Michael A. Berardi
Director
Service Engineering Operations
Ford Customer Service Division

SUBJECT: DEMONSTRATION / DELIVERY HOLD - Safety Recall 13S05
Certain 2013 Model Year Lincoln MKZ vehicles equipped with an Engine Block Heater
Engine Block Heater Cable Replacement

CERTAIN 2013 MODEL YEAR LINCOLN MKZ VEHICLES — BLOCK HEATER CABLE REPLACEMENT

FIGURE 2

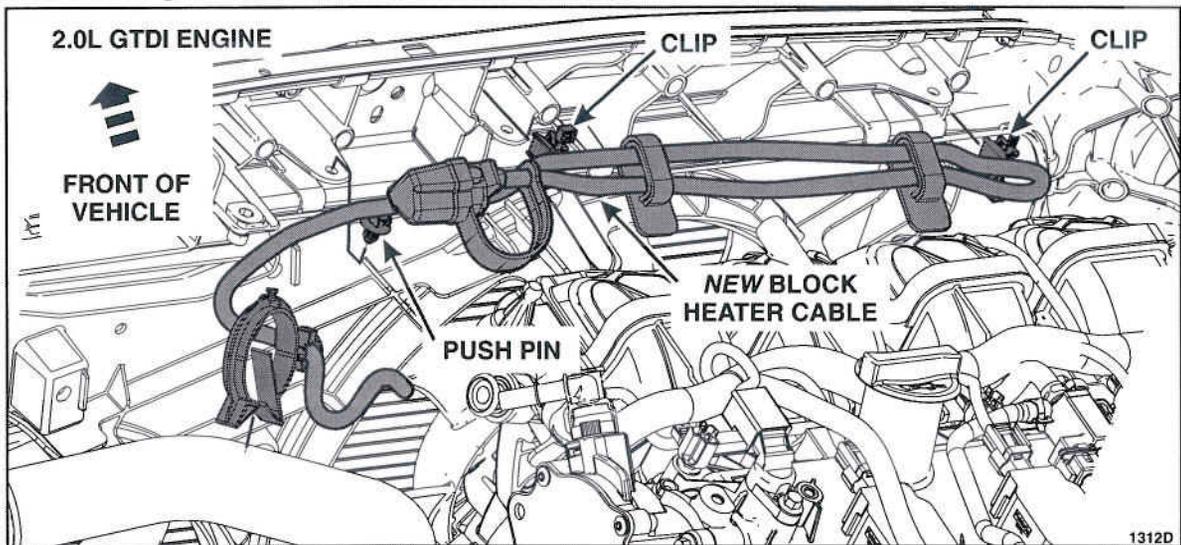
4. Install and route the *new* block heater cable. Attach the clips and push pins.

- See Figure 2 for 2.0L GTDI Engine - *New Block Heater Cable Routing*.
- See Figure 3, on Page 3 for 2.0L Hybrid Engine - *New Block Heater Cable Routing*.
- See Figure 4, on Page 4 for 3.7L GTDI -Engine - *New Block Heater Cable Routing*.

2.0L GTDI Engine - *New Block Heater Cable Routing*
